SERVICE BULLETIN

APPLICABILITY: 2019-23MY Ascent

SUBJECT: Front Strut / Design Change

NUMBER: 05-90-24

DESCRIPTION OF DESIGN CHANGE:

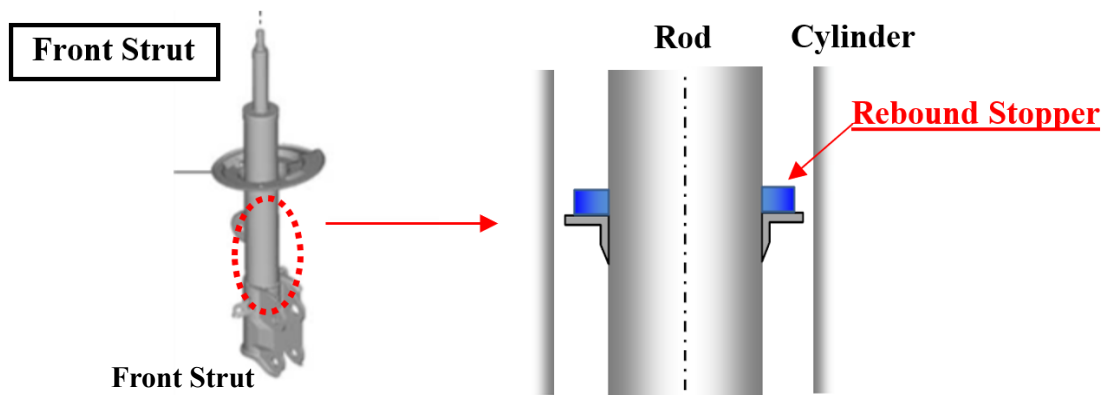
This bulletin announces the design change made to the front strut assemblies to address cases of a rumbling and/or rattling sound coming from the undercarriage when going over bumps. The internal rebound stopper of the strut has been resized to avoid deformation. If the sound is duplicated, replace only the affected strut assembly as they do not have to be replaced in pairs.
